Access Compliance Report

Public Rights-of-Way

(Curb Ramps)

Intersection ID: 21445	Main Street: CHAMPAIGN_ST	Cross Street: COTILLION_AV	Location:	N
ADA ID: DC28C1478D56	Ramp Type: PerpDiag	Initial Pass/Fail: Fail	Overall Compliance: No	Severity Score: 37.5
Codes/Mitigation Info/Possible Solution		Field Measurements/Component Compliance

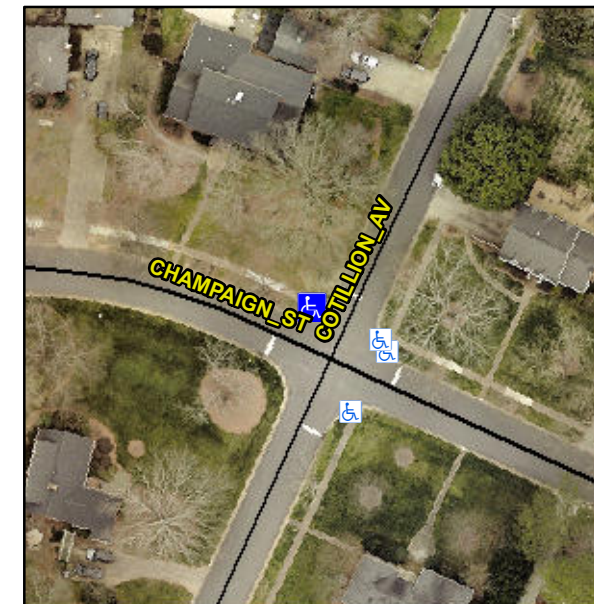
Not Found, R304.2.2, R304.5.3

Compliance	Description	Data	Compliance	Description	Data
N/A	Ramp Length (in)	33.5	No	Ramp Slope (%)	11.4
Yes	Ramp Width (in)	68.0	No	Ramp XSlope (%)	8.1
N/A	Flare Type LT	N/A	N/A	Flare Type RT	N/A
N/A	Flare Slope LT (%)	N/A	N/A	Flare Slope RT (%)	N/A
N/A	Flare Traversable LT?	N/A	N/A	Flare Traversable RT?	N/A
N/A	Landing Length (in)	N/A	N/A	DWS Provided?	N/A
N/A	Landing Width (in)	N/A	N/A	DWS Contrast?	N/A
N/A	Landing Slope (%)	N/A	N/A	DWS Length (in)	N/A
N/A	Landing X Slope (%)	N/A	N/A	DWS Full Width?	N/A
N/A	Landing Curb? (Y/N)	N/A	N/A	DWS Offset (in)	N/A
N/A	Shared Landing?	N/A			
N/A	Gutter Ponding?	N/A	N/A	Gutter Slope (%)	N/A
N/A	Gutter Lip Ht (in)	N/A	N/A	Gutter X Slope (%)	N/A
N/A	Painted X Walk1?	No	N/A	Painted X Walk2?	No
	X Walk 1 Direction	To SW		X Walk 2 Direction	To SE
N/A	X Walk 1 Width (in)	N/A	N/A	X Walk 2 Width (in)	N/A
	X Walk 1 Slope (%)	8.0		X Walk 2 Slope (%)	2.1
	X Walk 1 X Slope (%)	0.3		X Walk 2 X Slope (%)	7.9

Remove & Replace Curb Ramp With Two New Directional Ramps or Equivalent.
